David Weinstein
51 Freese Road
Ithaca, NY 14850

May 29, 2020

Dear Planning Board members,

Distorted visuals

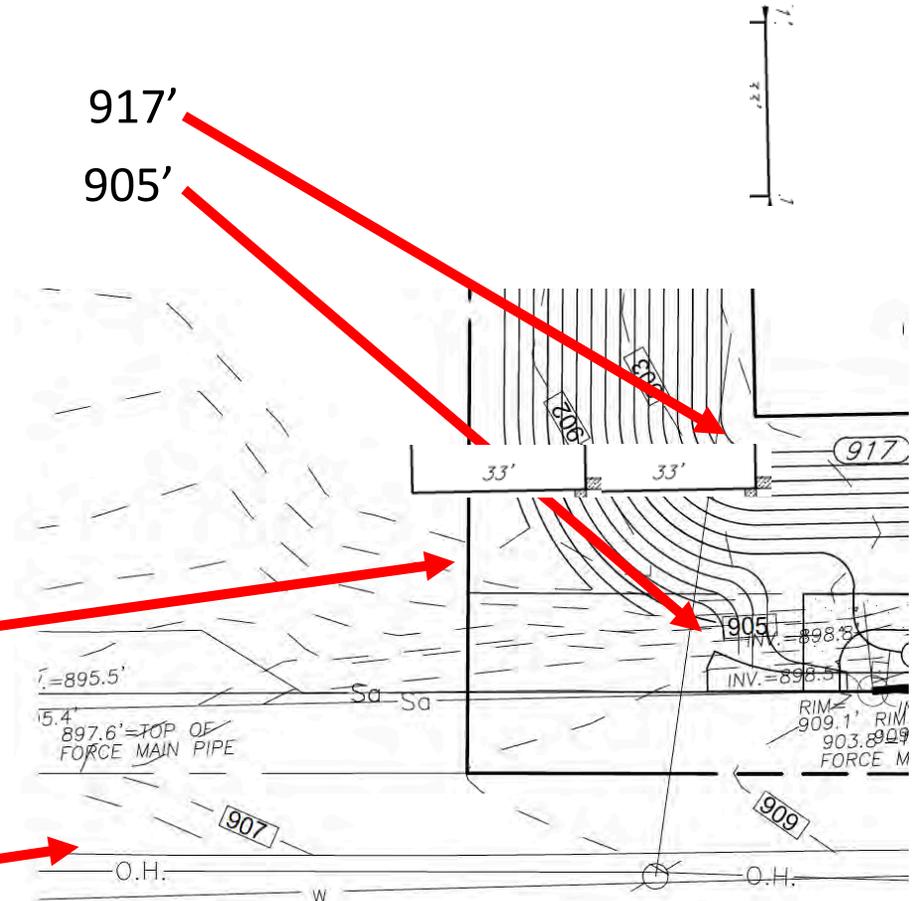
This looks like it cannot be more than 6', as the developer claimed at the meeting.

According to this claim, each story in the building could only be about 6' tall.

This tree is right next to the bottom of the fill pile 60' from the building, at 901'. If the building is 25' on a 12' base, this tree is 100' tall, and a record height in NY.

Picture taken from here, at about 904' (bridge is at 900'), about 150' from building.

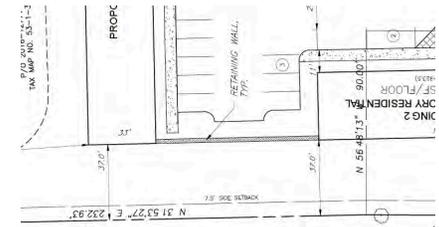
Look how much distance the visual shows will be between the hill and the road.

Compare to the distance shown on their grading plan. (Sidewalk, not depicted properly on visual, shown at 932'; edge of driveway lip is 921', an 11' difference). Does this look right to you?
